<p>CLAYTON COUNTY Water AUTHORITY</p> <p>1600 Battle Creek Road Morrow, GA 30260</p>	JONESBORO RPS IMPROVEMENTS	
	ADDENDUM 3	
	Date	Tuesday, May 7, 2024
	Bid Number	2024-WP-12
	Pre-Bid Meeting	Tuesday, April 23, 2024 at 2:00 p.m. local time
Bid Opening	Tuesday, May 14, 2024 at 2:00 p.m. local time	
ADDENDUM MUST BE SIGNED AND INCLUDED IN YOUR BID SUBMITTAL

ADDENDUM 3

JONESBORO RPS
IMPROVEMENTS

DETAIL	1
1" = 1'-0"

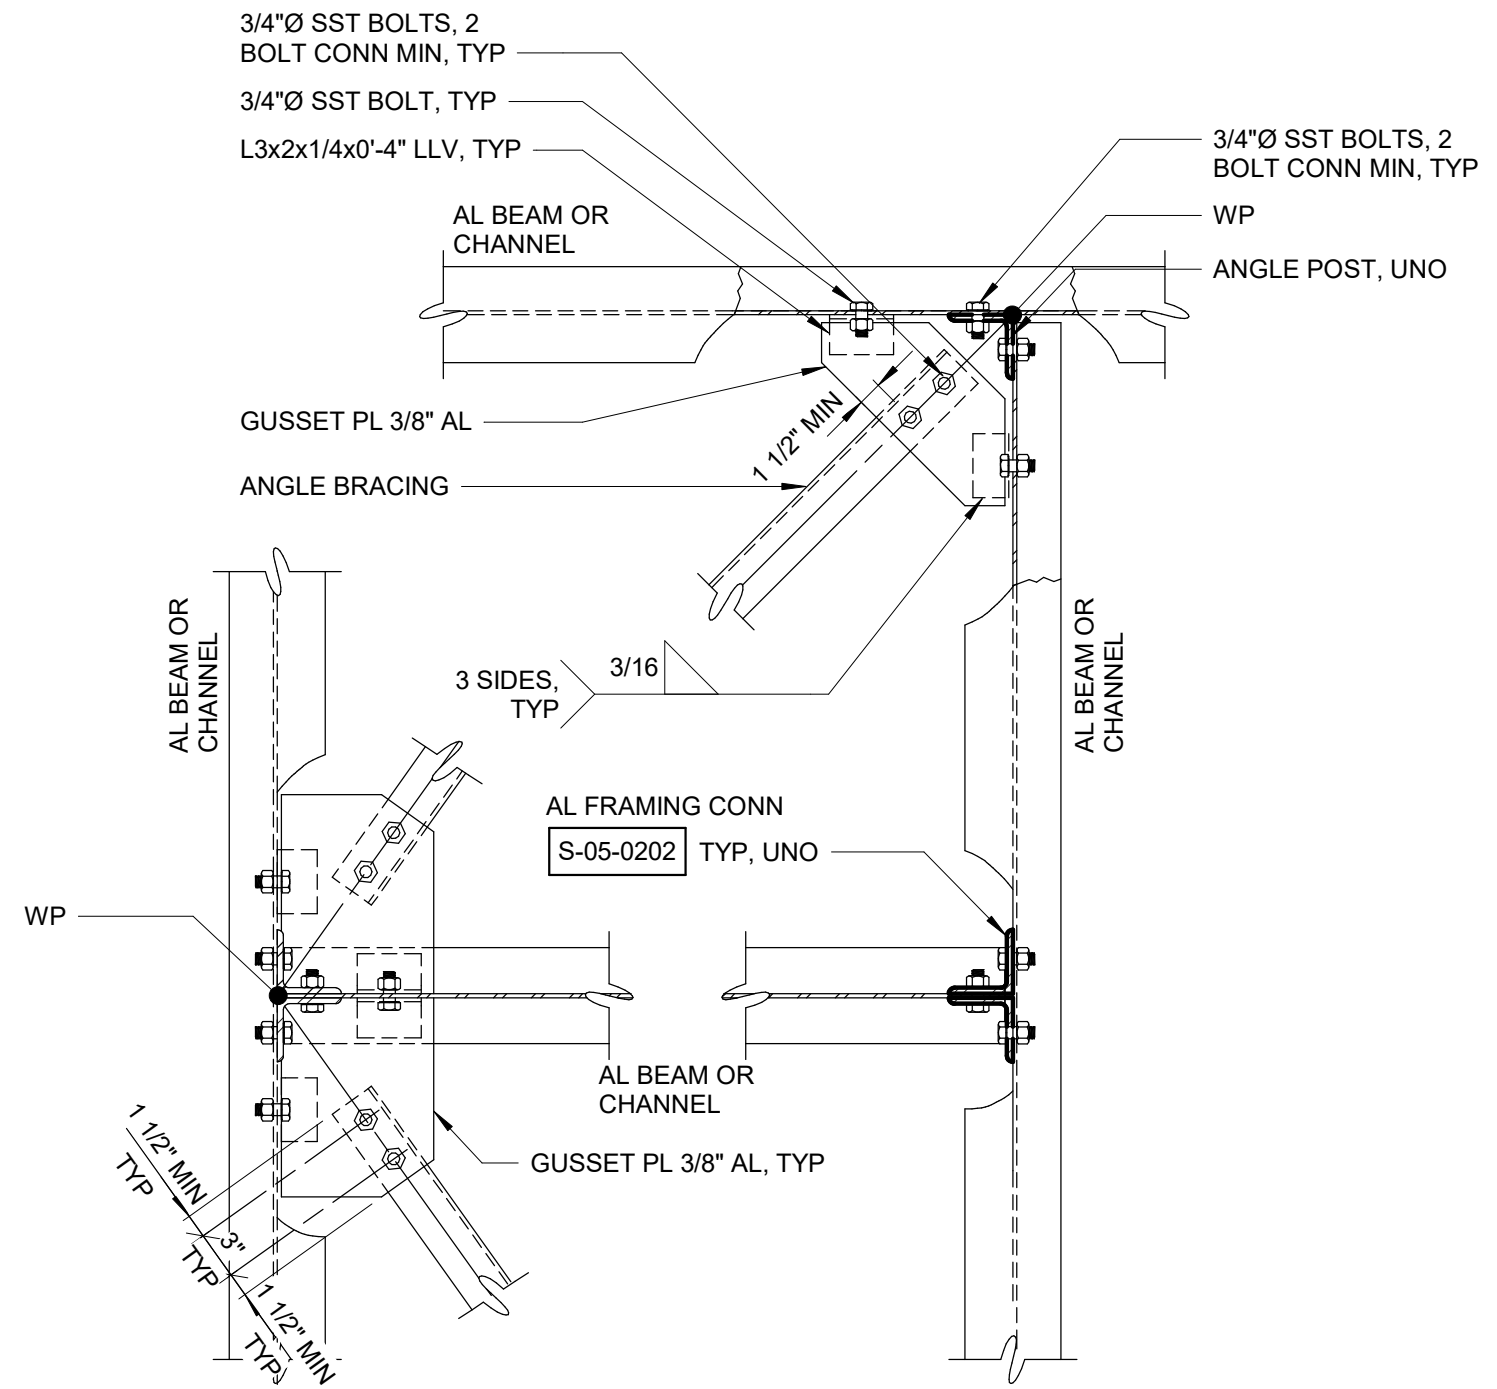
A. Drawing S550

- 1. Add the following note: ***“5. For aluminum platform column base plates see Detail 1 on Drawing S551. For aluminum platform framing connections see Detail 2 on Drawing S551.”***

Q8: Referencing S550 and S551, can a detail be provided for the base plates for the L4 columns at the generator platforms?

A. Details 1 and 2 add to Drawing S551

A8: See PART 4 – A in this Addendum 3.

ANGLE SIZE	PLATE SIZE
L3x3	6"x6"
L4x4	6"x6"
L5x5	7"x7"
L6x6	8"x8"

NOTE: ALL ADHESIVE ANCHORS SHALL BE 3/4"Ø SST ANCHOR WITH 6" MIN EMBED UNLESS NOTED ON DRAWINGS
